1985 Chevrolet Corvette V8-350 5.7L[Vehicle Level](#) → [Transmission and Drivetrain](#) → [Technical Service Bulletins](#) → [All Technical Service Bulletins](#) → [M/T - Noise With Automatic Overdrive Disengaged](#) ←**M/T - Noise With Automatic Overdrive Disengaged**[Notes](#)

85-111

Subject: NOISE IN DIRECT DRIVE 4-SPEED MANUAL TRANSMISSION

Model and Year: 1984-1985 CORVETTE

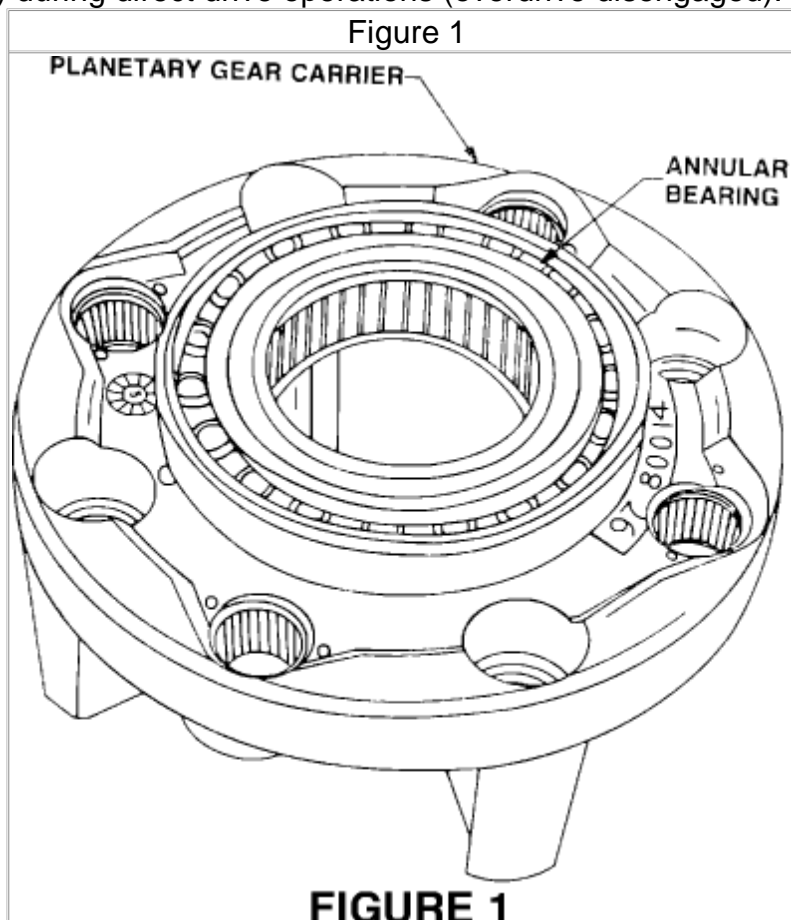
This condition may be caused by a worn annular bearing on the planetary gear carrier (see illustration). Continued operation of a noisy transmission in the direct drive mode will cause damage to the planetary carrier, adapter plate, input sun gear, and input sun gear oil seal. If the input sun gear oil seal is damaged, it is possible for overdrive unit oil (Dexron II) to leak into the manual portion of the transmission.

On transmissions beginning with serial number D5C 14413 CF, a new planetary gear carrier has been released. This carrier (P/N 14094571) incorporates an annular bearing with increased thrust capacity.

Complaint vehicles will have transmissions built prior to serial number D5C 14413 CF. These transmissions are to be repaired by disassembling the overdrive unit according to the appropriate section in the Vehicle Service Manual to enable the following to be carried out:

1. Inspect the adapter plate surface, input sun gear, and input sun gear oil seal for damage. If there is indication of damage, the adapter plate, input sun gear, and input sun gear oil seal should be replaced. If there is no sign of damage, these parts may be reused.
2. If debris is present in the overdrive unit, completely disassemble and clean the unit, including the [valve body](#).

3. If there is evidence of oil intrusion from the automatic overdrive unit into the 4-speed manual unit, the manual unit should be drained and flushed also.
4. Replace the planetary gear carrier with the new, P/N 14094571, carrier.

NOTICE: When an overdrive unit from a transmission built prior to serial number D5C 14413 CF is disassembled for any reason, it is recommended that a new, P/N 14094571, planetary gear carrier be installed to prevent potential future annular bearing failures.
